<b>Docket Number:</b>	17-BSTD-01
<b>Project Title:</b>	2019 Building Energy Efficiency Standards PreRulemaking
<b>TN #:</b>	220555
<b>Document Title:</b>	Against Mandatory Installation of Automated Sash Closure Devices
<b>Description:</b>	N/A
<b>Filer:</b>	System
<b>Organization:</b>	Thomas Smith
<b>Submitter Role:</b>	Other Interested Person
<b>Submission Date:</b>	8/4/2017 3:24:41 PM
<b>Docketed Date:</b>	8/4/2017

**Against Mandatory Installation of Automated Sash Closure Devices**

**To:** California Energy Commission - Statewide Codes and Standards Team  
**From:** Thomas C Smith  
**Subject:** Comments for California Energy Commission: Docket No. 17-BSTD-01, 2019 Building Energy Efficiency Standards PreRulemaking – Automatic Sash Closure Devices for VAV Fume Hoods  
**Date:** August 4, 2017

Figure 1 Diagram of typical components and attributes of a modern VAV laboratory ventilation system.

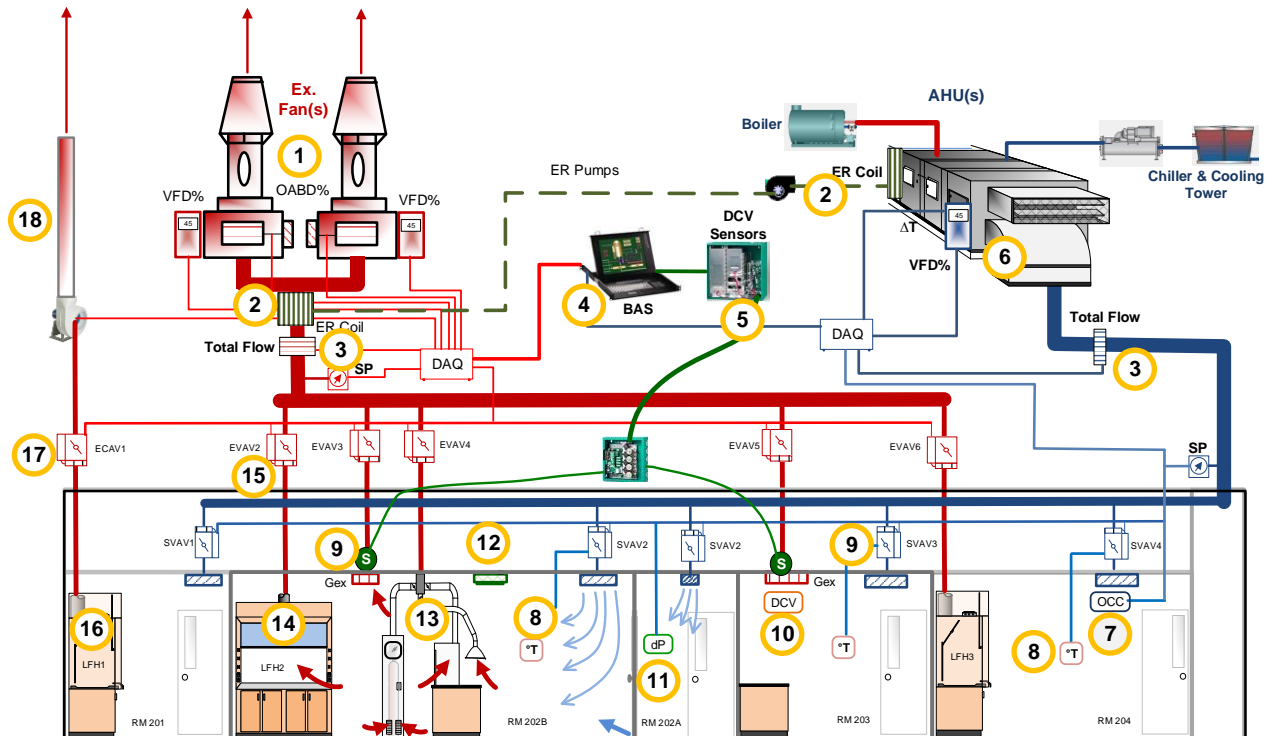
The design, construction, operation and use of laboratory fume hoods and ventilation systems affect the ability to control airborne chemicals, meet safety requirements and satisfy the building occupant’s demand for ventilation. Lab ventilation systems can range from simple, constant air volume (CAV), independent exhaust and supply systems to complex, variable air volume (VAV), manifolded systems capable of modulating airflow for multiple spaces to provide a range of operating modes. Figure 1 and the associated Table below depict and describe a complex, modern, VAV exhaust and air supply system capable of modulating flow in response to changes in the demand for ventilation such as opening and closing sashes on VAV fume hoods or responding to detection of airborne contaminants in the lab environment. The diagram is provided to exhibit and describe the number of systems, sub-systems and components that must operate properly to realize the savings associated with automatic sash closures. The number of components and complexity of operation coupled with a lack of skilled operators and standards for integration, testing and maintenance diminishes the probability of realizing significant long-term savings from installation of automatic sash closures.

**Figure 2 Elements of a Comprehensive LVMP**

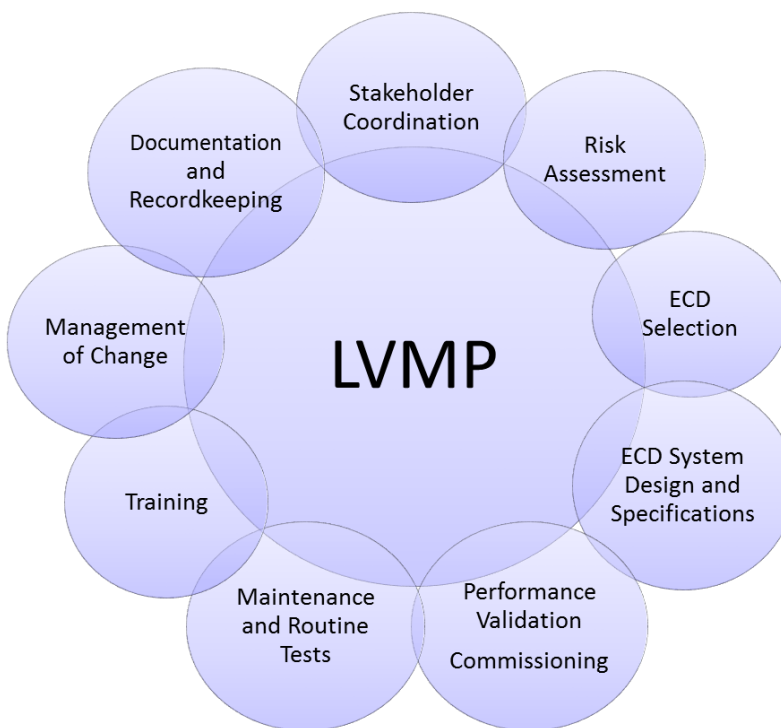
Consider mandating lab facilities implement LVMP as required by the ANSI/AIHA Z9.5-2012 American National Standard for Laboratory Ventilation. Section 2.1 of the standard states “An LVMP shall be implemented to ensure proper operation of the lab ventilation systems, help protect laboratory working with potentially hazardous airborne materials, provide satisfactory environmental air quality and maintain efficient operation of the laboratory ventilation systems.” The cost burden to install automatic sash closures will more than offset the cost of implementing a LVMP for most facilities. Figure 2 depicts the elements of a comprehensive LVMP.

Most importantly, maximizing both lab safety and energy reduction can be realized by provision of training, guidelines and standards to assist lab facilities with design, operation and management of modern, highly complex, multi-component, VAV lab ventilation systems. Consider providing the methods, tools and standards to help facilities ensure efficient and effective operation. Provide guidelines and methods to measure, monitor and maintain proper performance over the lifecycle of the systems. An effective monitoring program with appropriate analytics combined with management of change and training will provide the most efficient and cost-effective solutions.
